Montana Fish, Wildlife & Parks

The enclosed Supplemental Environmental Assessment (EA) has been prepared for the proposed construction of parking improvements for walk-in access to Henneberry Fishing Access Site (FAS) south of Dillon, Montana. Changes in project location and scope have warranted the amendment of the original EA with the information in the attached Supplemental EA.

**SUPPLEMENTAL REVISION
TO THE
HENNEBERRY FISHING ACCESS SITE
WALK-IN PARKING LOT DEVELOPMENT
ENVIRONMENTAL ASSESSMENT**

Attachment A – Area overview showing the original project locations and the revised (new) site location.

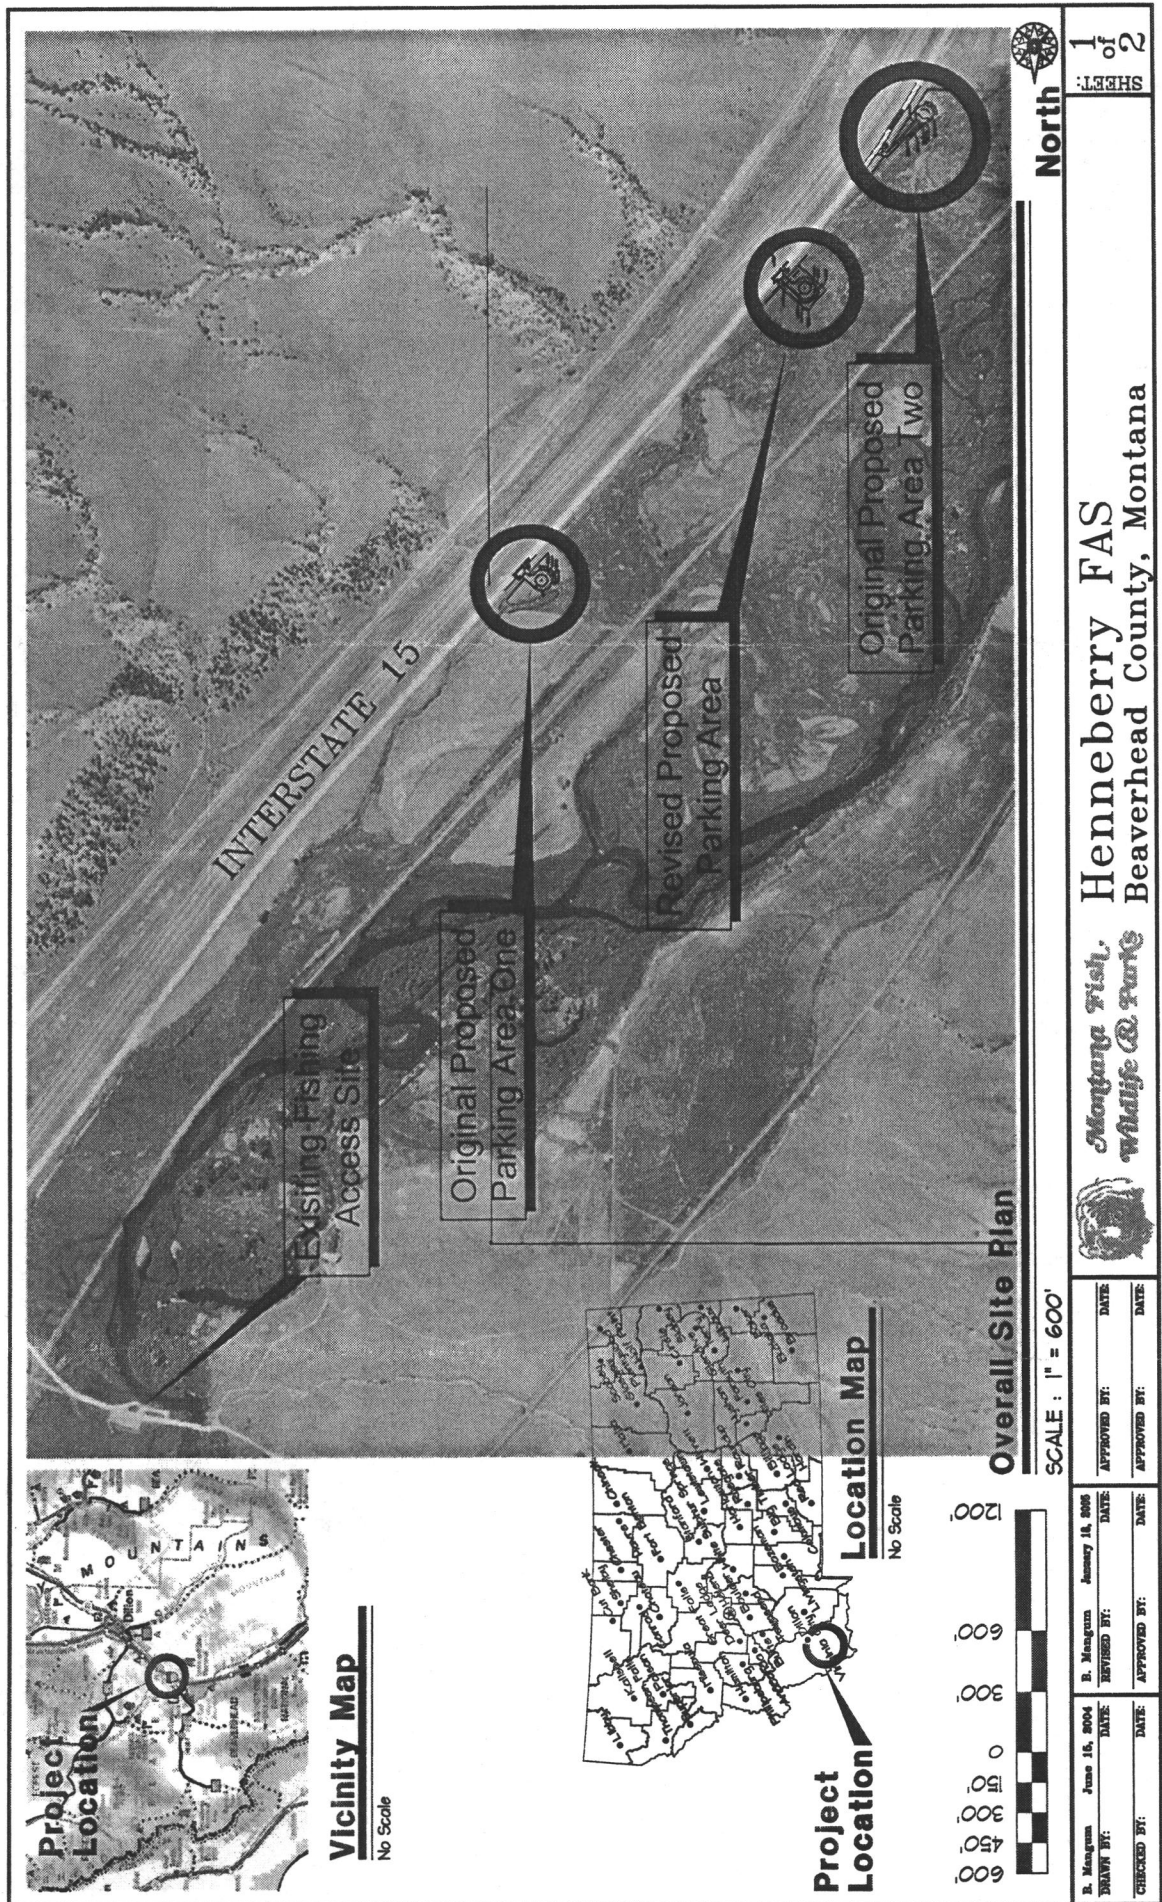
The revised proposed project would provide one constructed parking area for up to seven vehicles to accommodate walk-in anglers and waterfowl hunters at the south parcel of Henneberry FAS. The new parking lot and access ramp would be built between the two existing primitive parking areas being used now (and between where the two new ones were initially proposed), and would provide a level, easily accessible and safe place to park. Currently, the two primitive parking areas being used along the recreation road right-of-way are inconvenient, are causing negative resource impacts and compromise driver safety. The components of this project would include a filled/built-up access ramp off the recreation road, an irrigation ditch culvert for the access ramp crossing, a graveled parking lot with a cul-de-sac/island design, barrier rocks, livestock gate and signing.

Along with the construction of this one central parking lot, the two existing primitive right-of-way parking areas would be reclaimed and abandoned. These sites would be signed to direct users to the designated new lot and the entrances to FWP property would be re-fenced.

The original EA defined Alternative C as the "Preferred Alternative". For the purposes of this supplemental EA, the new "Preferred Alternative" becomes Alternative E, the new proposed action. As explained above, Preferred Alternative E would propose construction of one, seven-car lot instead of the two previously proposed at their current locations. Unlike the original Alternative B, which analyzed the building of just one lot at one of the current locations, Alternative E would abandon and reclaim the two currently used primitive access/parking areas, and would move the new lot construction to a location in between the two.
